ST. TAMMANY PARISH

Addendum No.: 4

Bid#: 19-01-2

Project Name: Lift Station and Blower Control Electrical Panels

ATTACHMENT "A"-REVISED

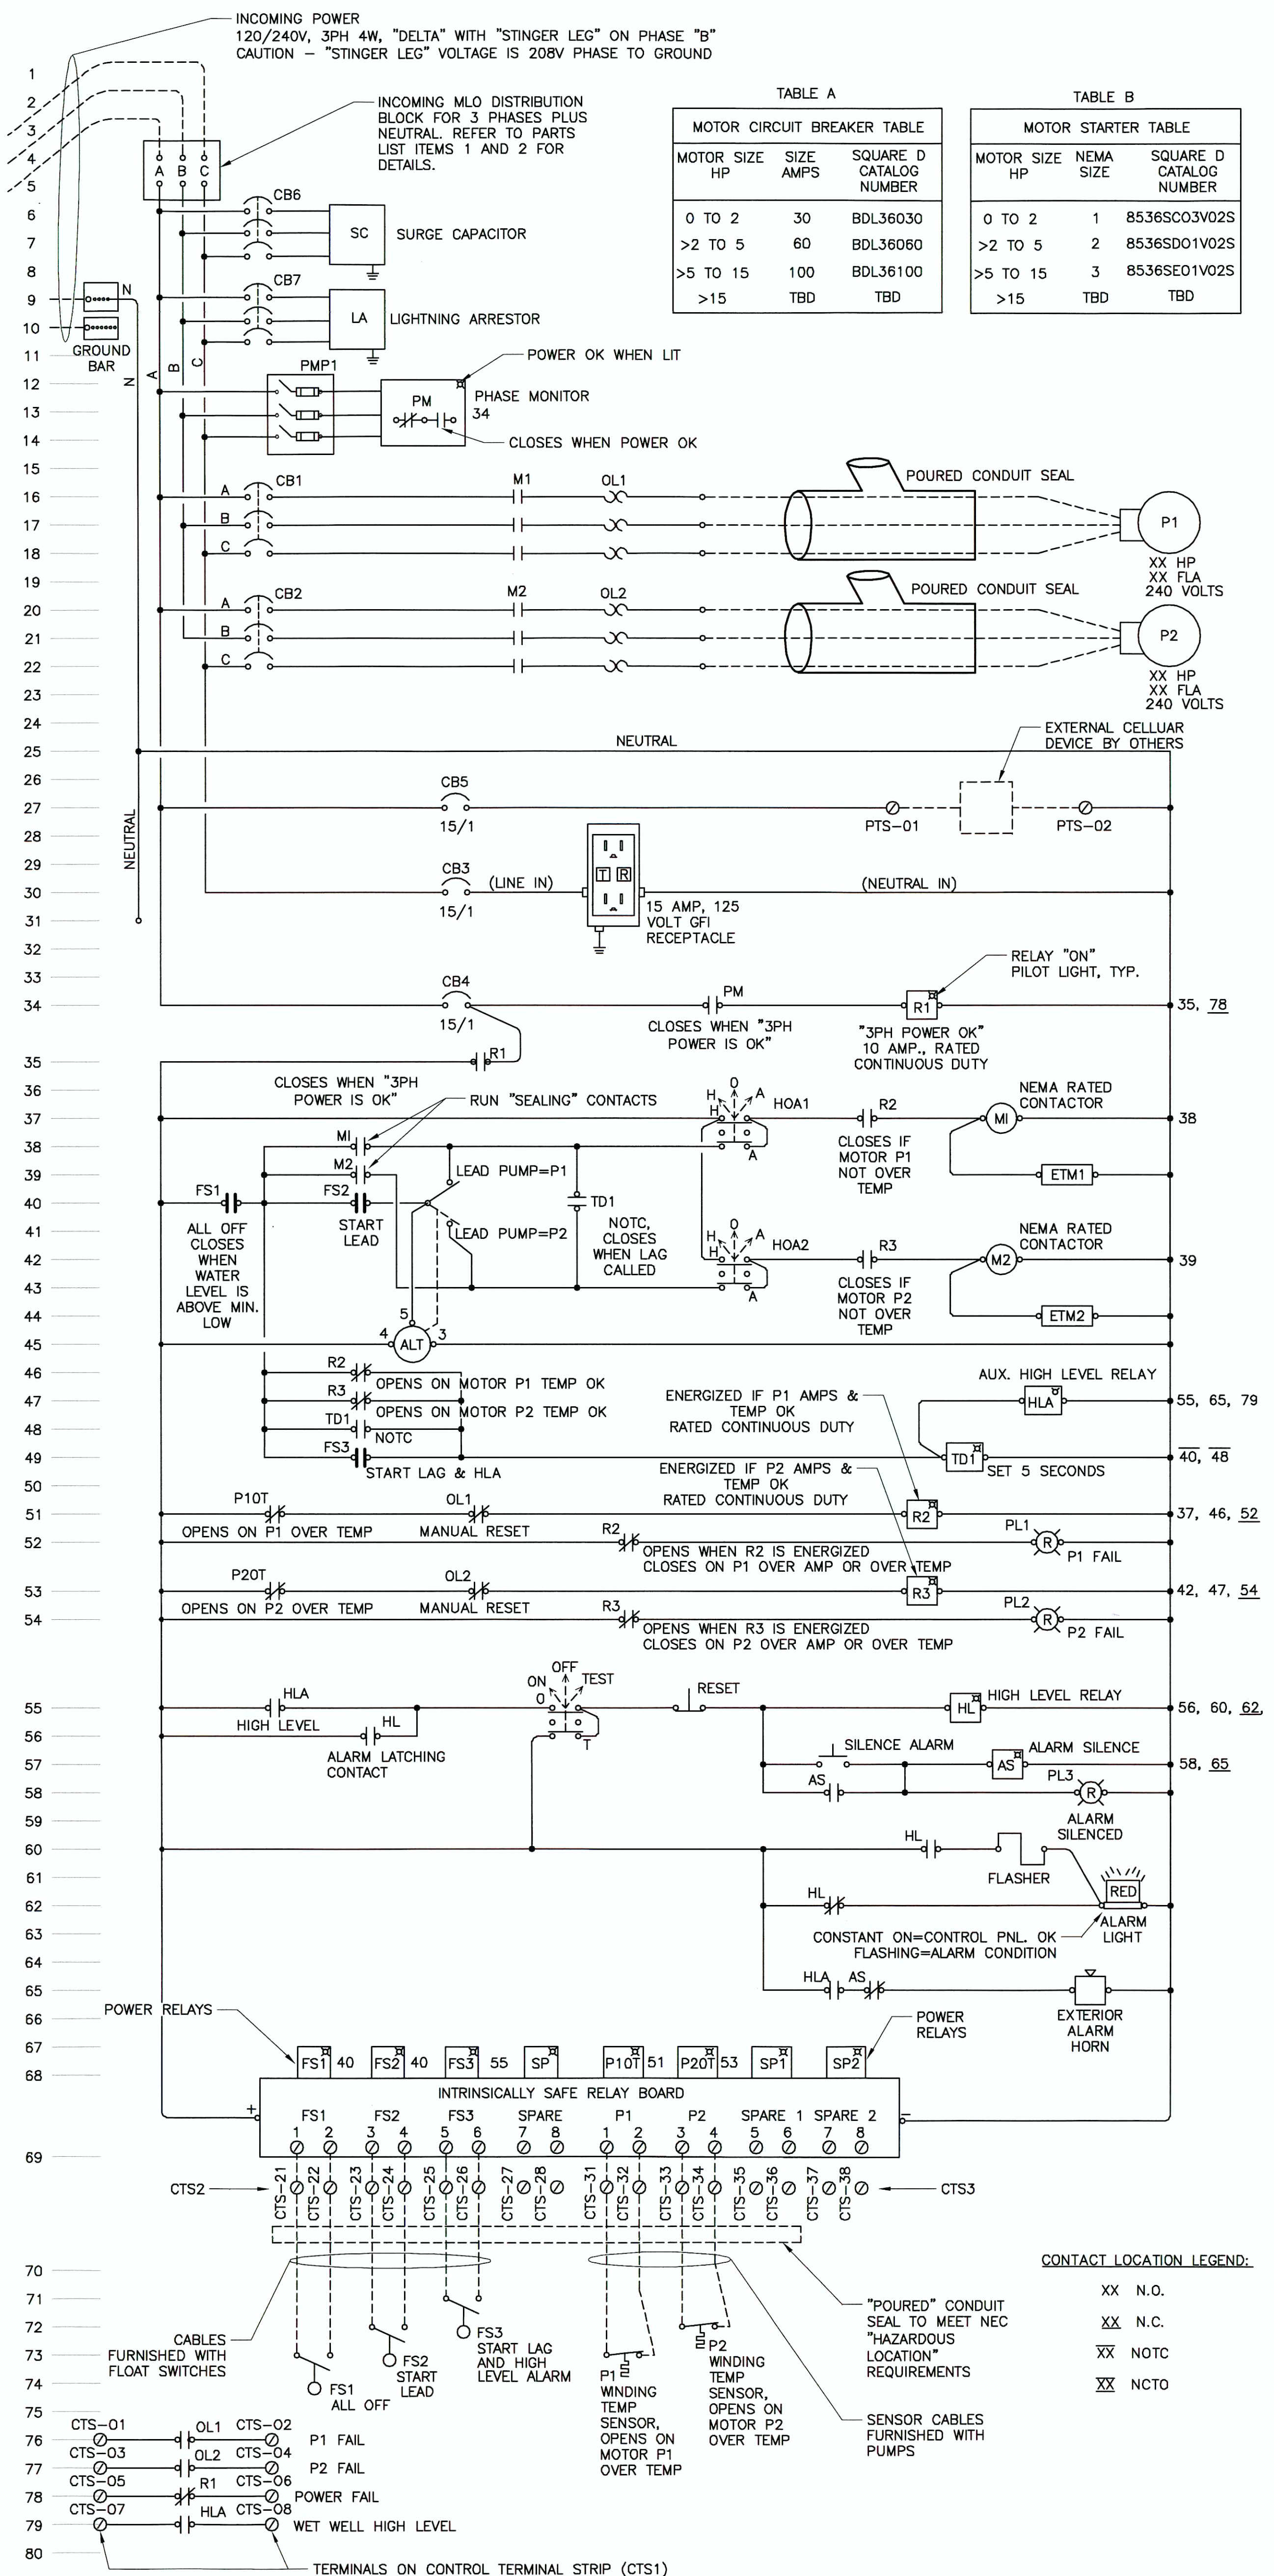
3. Please delete **Attachment "A" 240 Volt Duplex Lift Station Standard Control Panel** and replace with **Attachment "A"-REVISED 240 Volt Duplex Lift Station Standard Control Panel** (Attached). The drawing has been modified to include an audible alarm.

- Attachment C Revised-2 is the same as above.
- Also in the schematic, you do *not* ask for an *audible alarm* but ask for a *silence circuit* to be provided.....do you want audible alarm on the panels?
Please verify.

Attachment “A”-REVISED 240 Volt Duplex Lift Station Standard Control Panel (Attached) and Attachment “B”-REVISED-2 480 Volt Duplex Lift Station Standard Control Panel (Attached) have been modified to include an audible alarm.

REVISIONS		APP'D
DATE:	REMARKS:	
2/5/19	MODIFIED NOTES 9 & 30, ADDED NOTE 44	BDB
2/5/19	ADDED AUDIBLE ALARM	BDB
2/5/19	MODIFIED WIRING LINES 37 THRU 65	BDB

ATTACHMENT "B"-REVISED-2

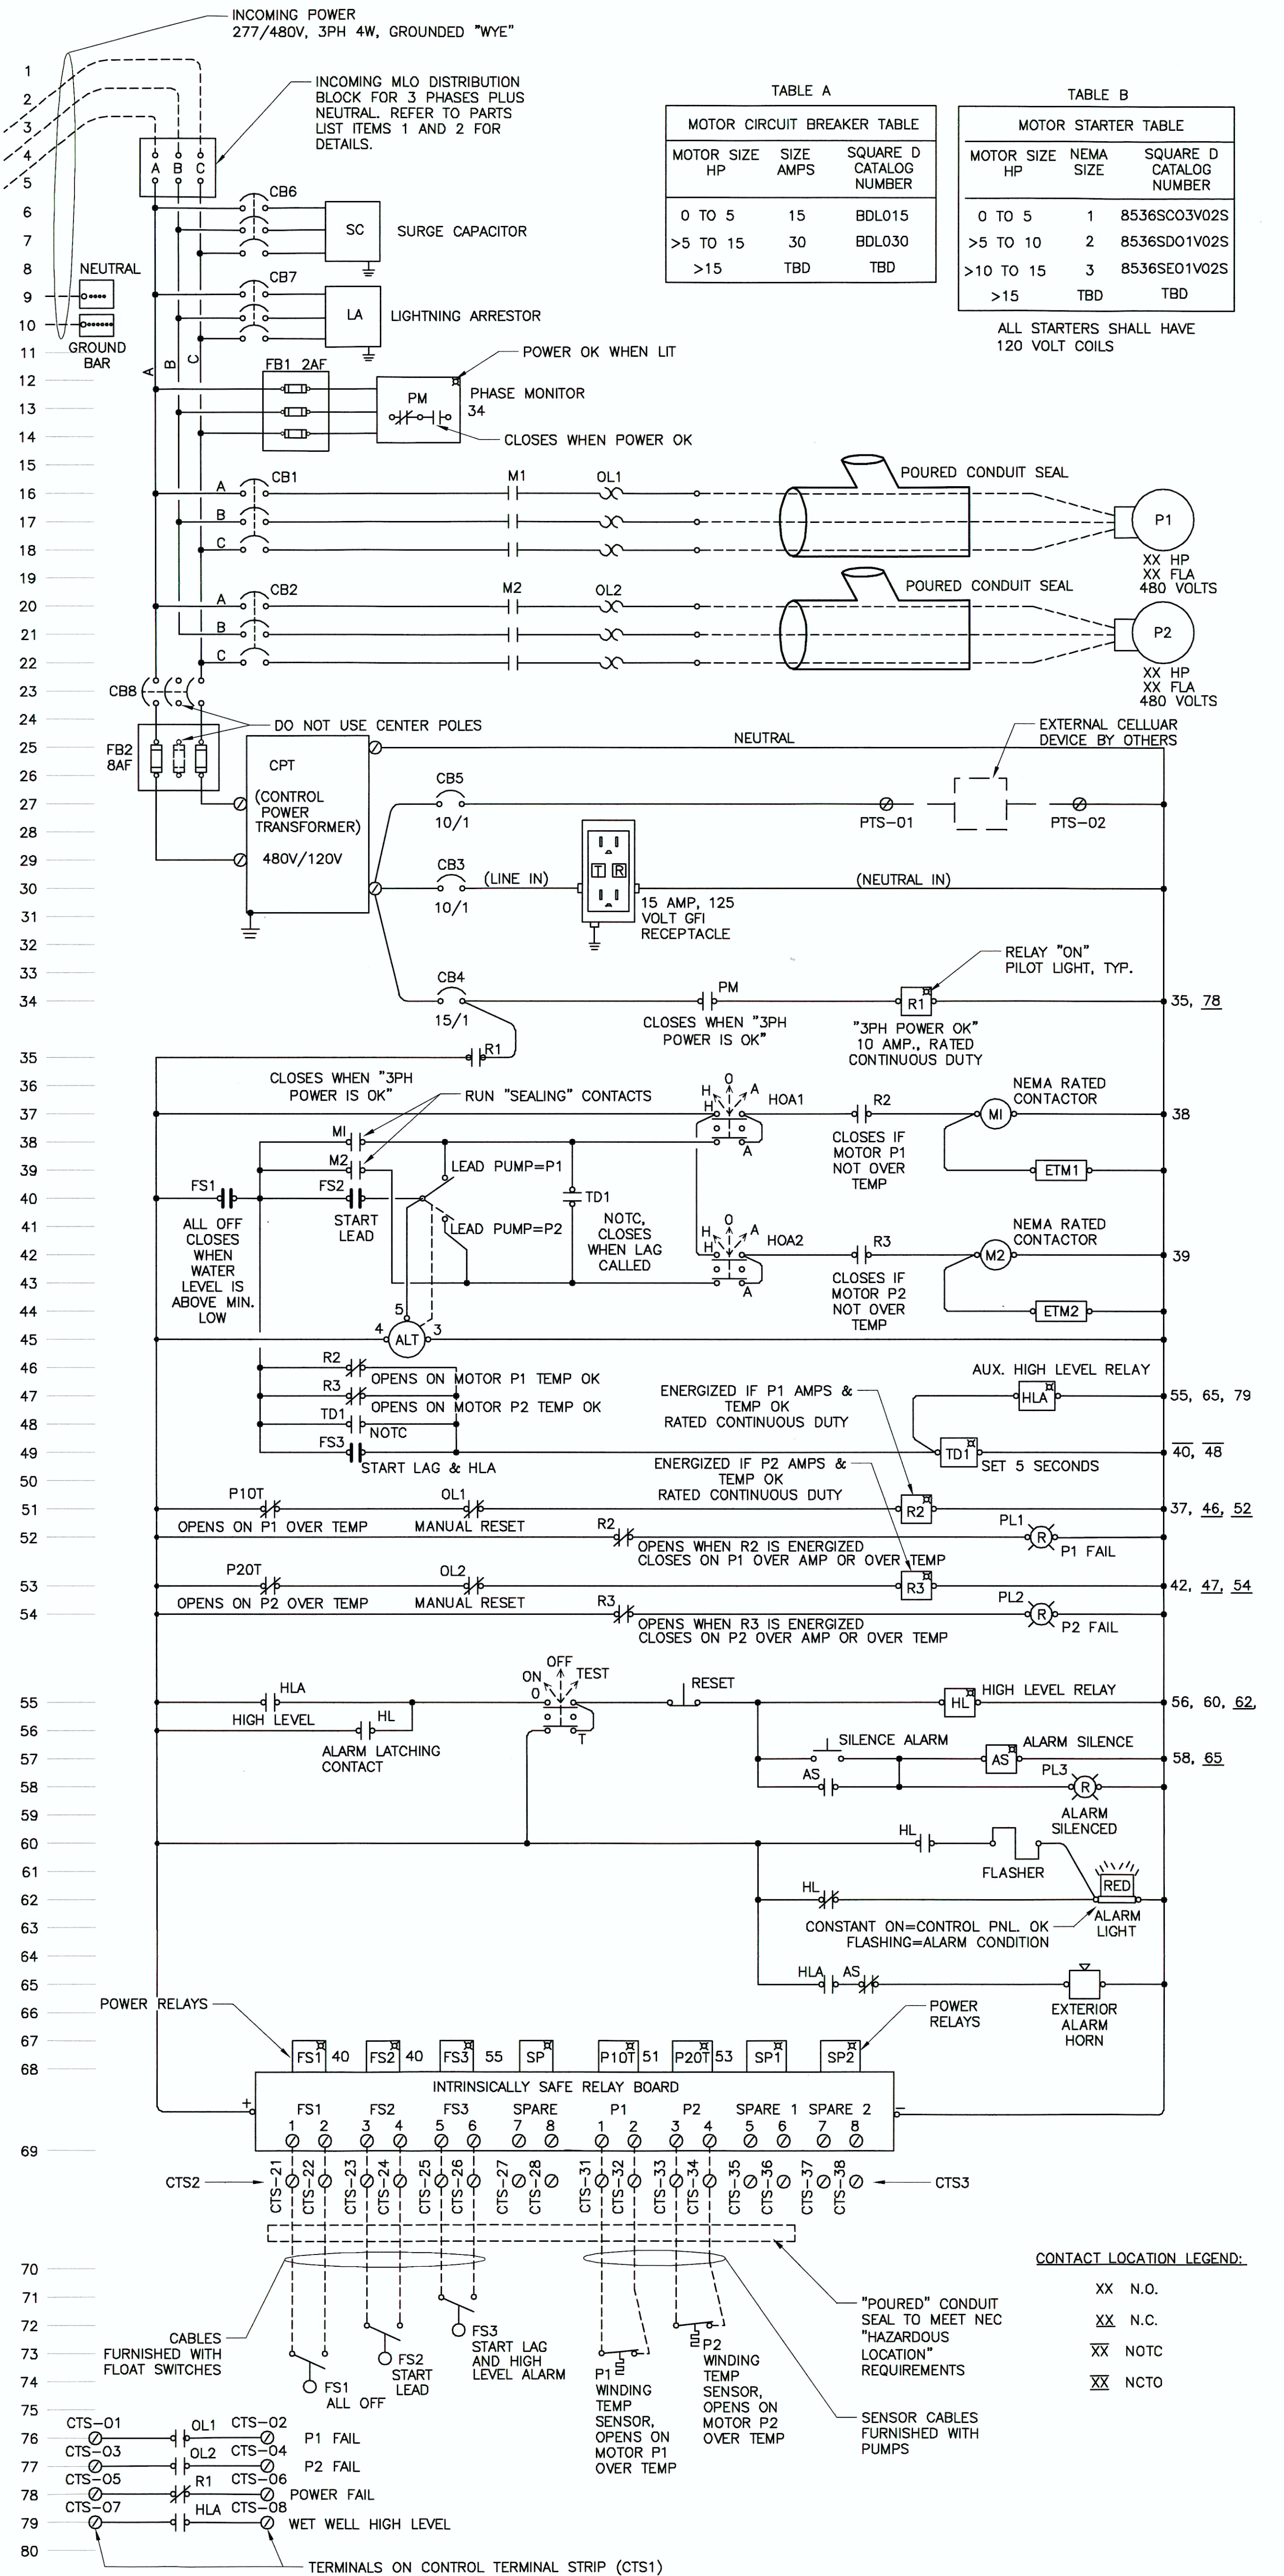
4. Please delete **Attachment "B"-REVISED 480 Volt Duplex Lift Station Standard Control Panel** and replace with **Attachment "B"-REVISED-2 480 Volt Duplex Lift Station Standard Control Panel** (Attached). The drawing has been modified to include an audible alarm and to require an 18KAIC rating for motor starter circuit breaker.

Question #1: Attachments B – Revise *item #9* requires a 25KAIC rating at 480 volt for the motor circuit breakers. As per *Table A* you specify BDL circuit breakers which are only rated at 18KAIC at 480 voltyou would need to specify the BGL with is rated for 35KAIC at 480 volt

Answer #1: **Note No. 9 has been revised to require an 18KAIC rating for motor starter circuit breaker on Attachment “B”-REVISED-2 480 Volt Duplex Lift Station Standard Control Panel (Attached) and Attachment “C”-REVISED-3 480 Volt Blower Standard Control Panel (Attached).**

ATTACHMENT "C"-REVISED-3

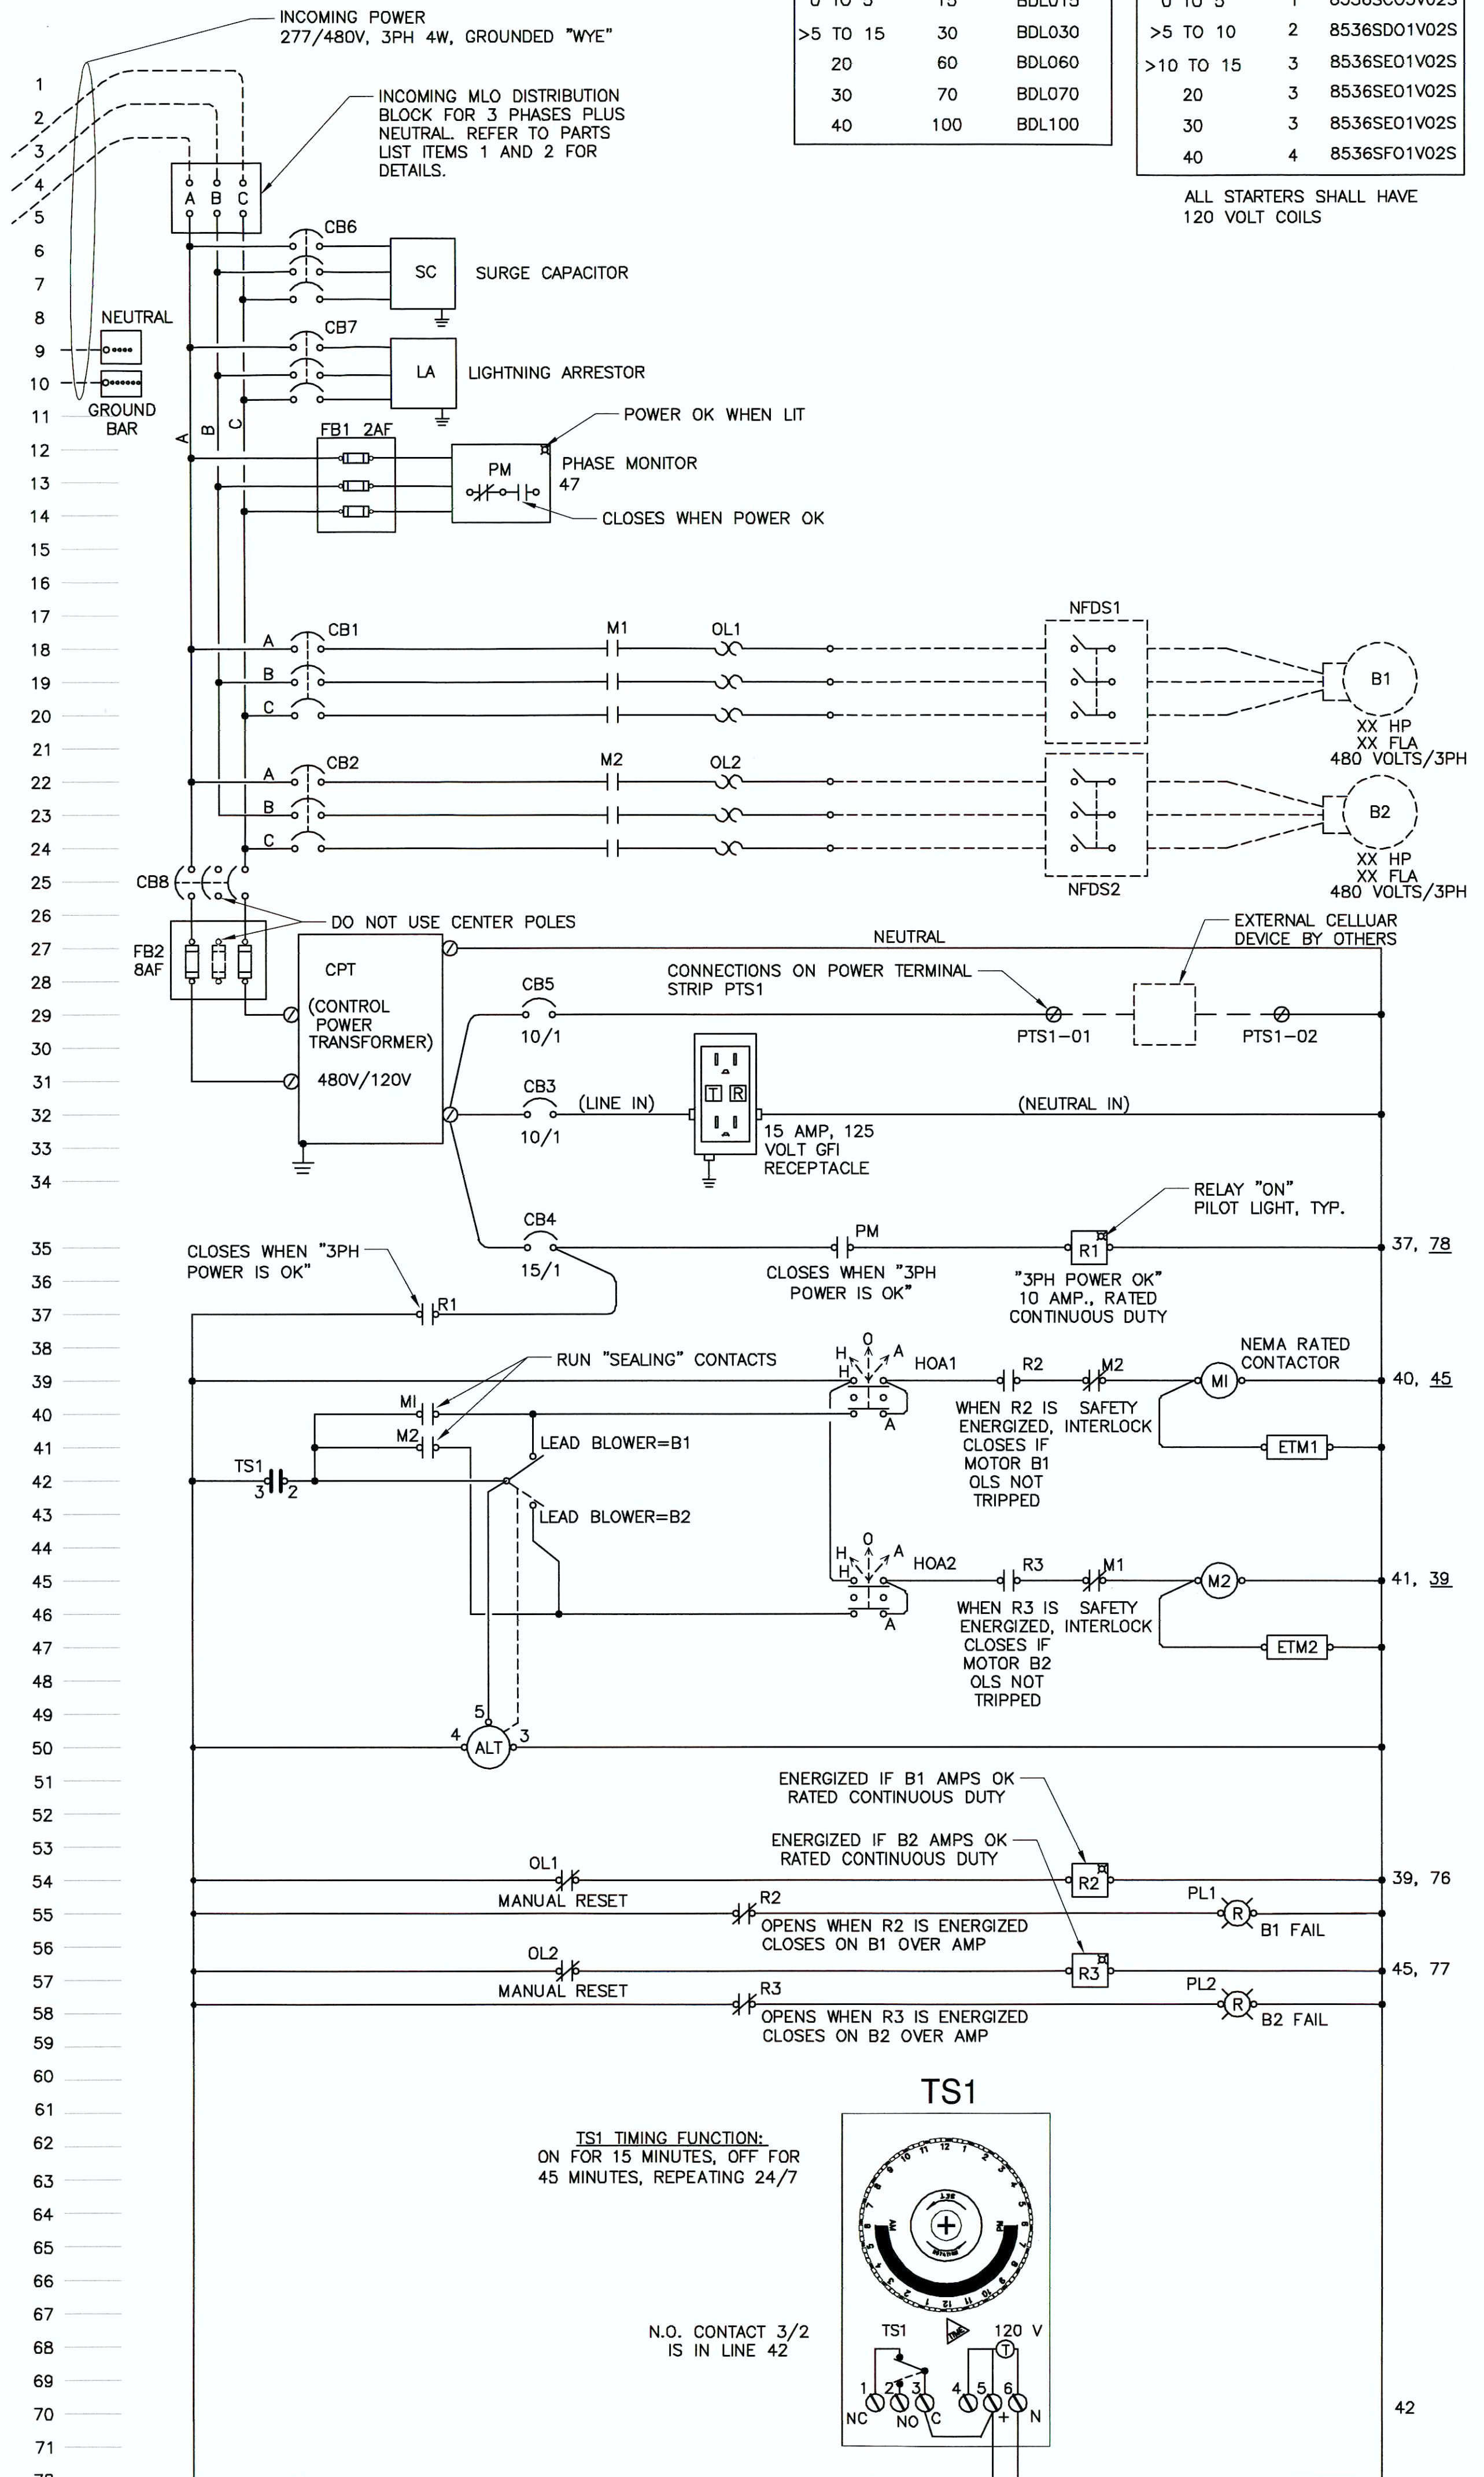
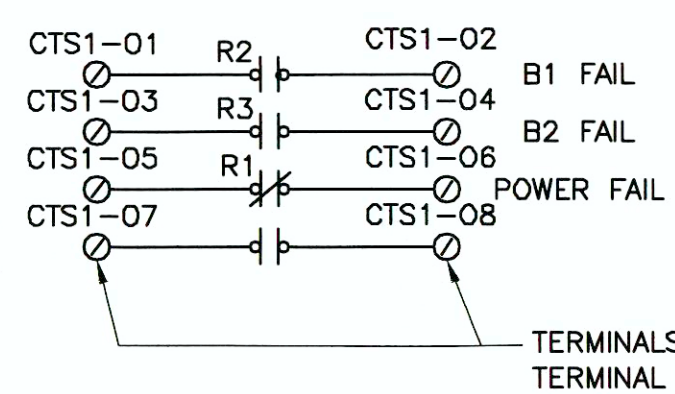
5. Please delete **Attachment "C"-REVISED-2 480 Volt Blower Standard Control Panel** and replace with **Attachment "C"-REVISED-3 480 Volt Blower Standard Control Panel** (Attached). The drawing has been modified to require an 18KAIC rating for motor starter circuit breaker.

SHEET NO. 1 OF 1	480 VOLT BLOWER STANDARD CONTROL PANEL ST. TAMMANY PARISH LOUISIANA	SCALE: (24x36) N.T.S.	DESIGNED BY: BDB			REVISIONS		CADD FILE NAME: 480V Blower CP
		SCALE: (11x17) N.T.S.	DRAWN BY: DLB			DATE: 1/28/19	REMARKS: MODIFIED TABLE A & B	
WIRING DIAGRAM AND PARTS LIST		DATE: NOV. 2018	CHECKED BY: BDB	PRINCIPAL Engineering, Inc. 1011 N. CAUSEWAY BLVD., SUITE 19 MANDEVILLE, LA 70471	PH: (985) 624-5001 info@pi-acc.com www.pi-acc.com	DATE: 2/1/19	REMARKS: MODIFIED TABLE A & B	APP'D: BDB
						DATE: 2/5/19	REMARKS: MODIFIED NOTE 9	APP'D: BDB
